Title - Sujet Snootli Creek Hatchery Aeration Fac	
Solicitation No. - N° de l'invitation F1700-211944/A	Amendment No. - N° modif. 001
Client Reference No. - N° de référence du client F1700-211944	Date 2021-11-25
GETS Reference No. - N° de référence de SEAG PW-\$PWY-031-9077	
File No. - N° de dossier PWY-1-44133 (031)	CCC No./N° CCC - FMS No./N° VME
Solicitation Closes - L'invitation prend fin at - à 02:00 PM Pacific Standard Time PST on - le 2021-12-07 Heure Normale du Pacifique HNP	
F.O.B. - F.A.B.	
Plant-Usine: <input type="checkbox"/> Destination: <input checked="" type="checkbox"/> Other-Autre: <input type="checkbox"/>	
Address Enquiries to: - Adresser toutes questions à: Leung, Janie	Buyer Id - Id de l'acheteur pwy031
Telephone No. - N° de téléphone (778) 919-3273 ()	FAX No. - N° de FAX (604) 775-6633
Destination - of Goods, Services, and Construction: Destination - des biens, services et construction: DFO – Snootli Creek Hatchery – Bella Coola, BC

This Amendment 001 is raised to issue Addendum 001.

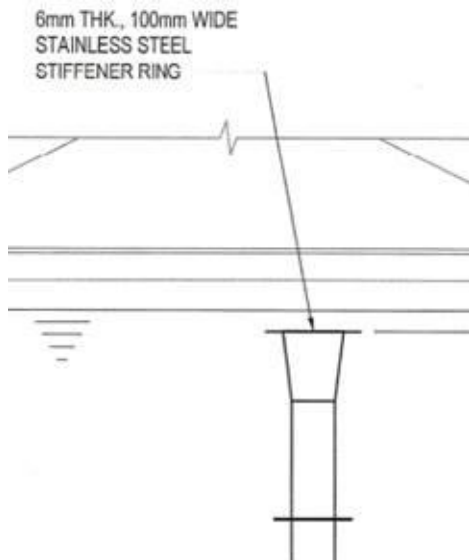
Q2. On drawing C-009 can you please provide a detail to where the 6 locations are? I only see 2 on the drawings.

A2. *The are six locations along the top, horizontal run of pipe that turns up to connect to the underside of the distributor tray : one at the underside of distributor tub, one at the flange end of the vertical pipe bend, one at the “inside” structural support (see Dwg -S-008, Sections K, L & M) for the horizontal pipe run, one on each side of the expansion-contraction joint, and one at the “outside” structural support for the horizontal pipe run.*
